**PRELIMINARY DRAINAGE REPORT
FOR
CLOVERLEAF SUBDIVISION PRELIMINARY PLAN**

PCD File No. SP202

**September 9, 2020
Project No. 25158.01**

SWALE CROSS SECTIONS
CLOVERLEAF SUBDIVISION
JOB NO. 25158.01
09/09/2020
SHEET 5 OF 6

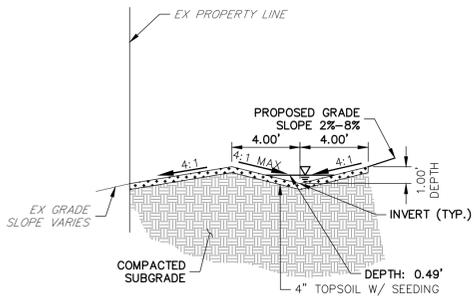
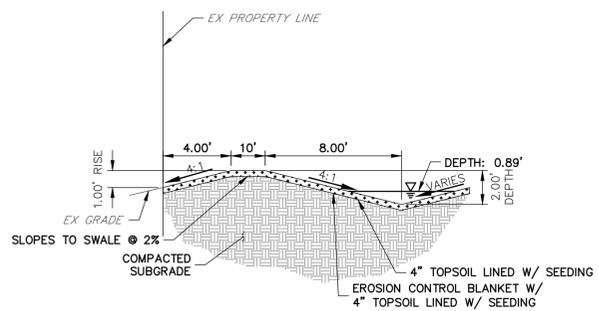
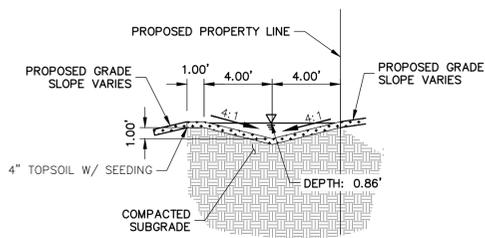
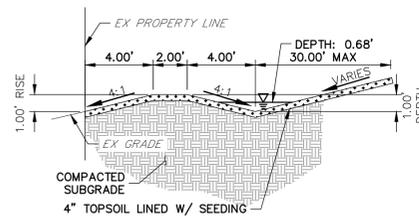
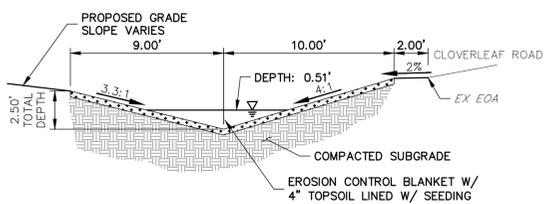
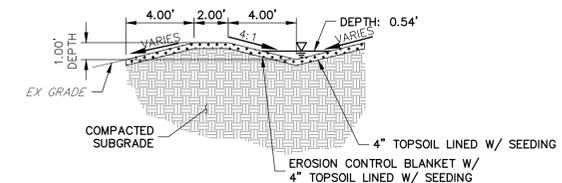
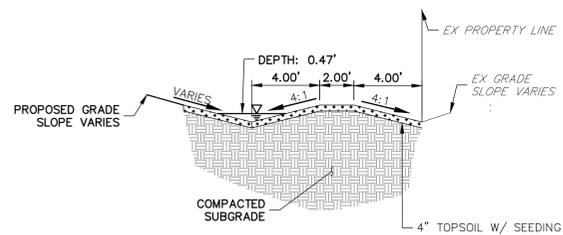
Update cross sections per review 2 redline comments on the preliminary plan cross sections
